# Recall of aluminum air cylinders

During product observation and quality control measures the J. G. ANSCHÜTZ GmbH & Co. KG has found out that a certain production lot may show material defects at the compressed air cylinders of target air rifles.

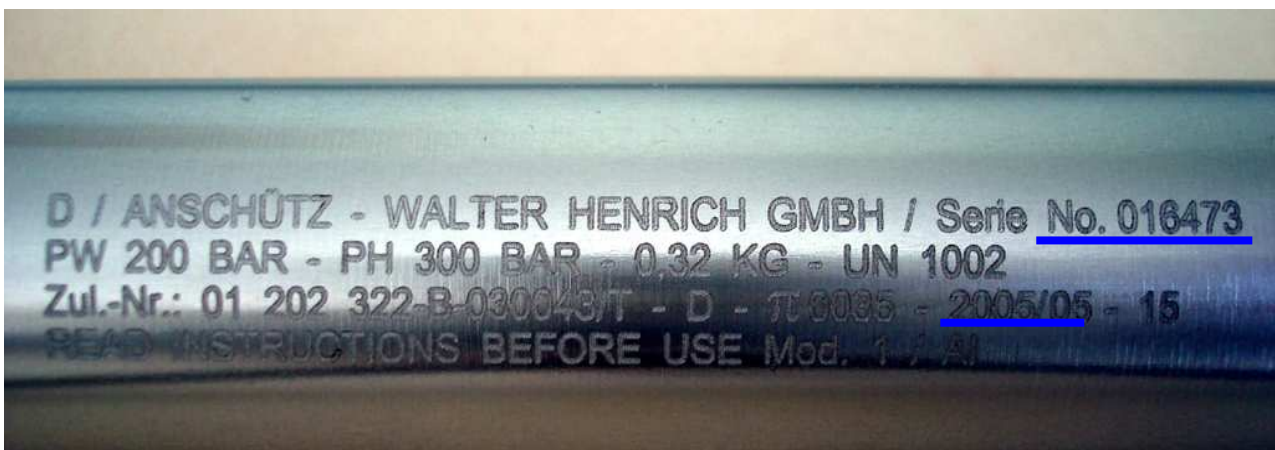
For safety reasons a check and - if necessary - exchange by the manufacturer is essential. The below listed air cylinder series – only until year of manufacture December 2005 - may be concerned:

- **Air cylinder, silver, length 430 mm:** from **012947** to **016846**, Item-No. 711.3415
- **Air cylinder, red, length 430 mm:** from **002444** to **002527**, Item-No. 711.3414
- **Air cylinder, black, length 430 mm:** from **000006** to **000053**, Item-No. 711.3413
- **Air cylinder, Junior, length 290 mm:** from **001632** to **002225**, Item-No. 711.3412

The above mentioned blue numbers are indestructibly engraved on your air cylinder. For the position of the serial number and the year of manufacture on the air cylinder see below picture, it is marked in blue. Please control your air cylinder immediately. When the number on your air cylinder matches with one of the above mentioned numbers, then empty your air cylinder. It must not be filled again.

Without check the concerned air cylinders must not be used anymore. They must be emptied immediately according to attached procedure.

Please send the concerned, empty air cylinder directly to J. G. ANSCHÜTZ GmbH & Co. KG, department "air cylinder check", Daimlerstr. 12, 89079 Ulm / Germany, for check, or send it to any authorized ANSCHÜTZ sales partner in your country. Our sales partners are listed on our website.
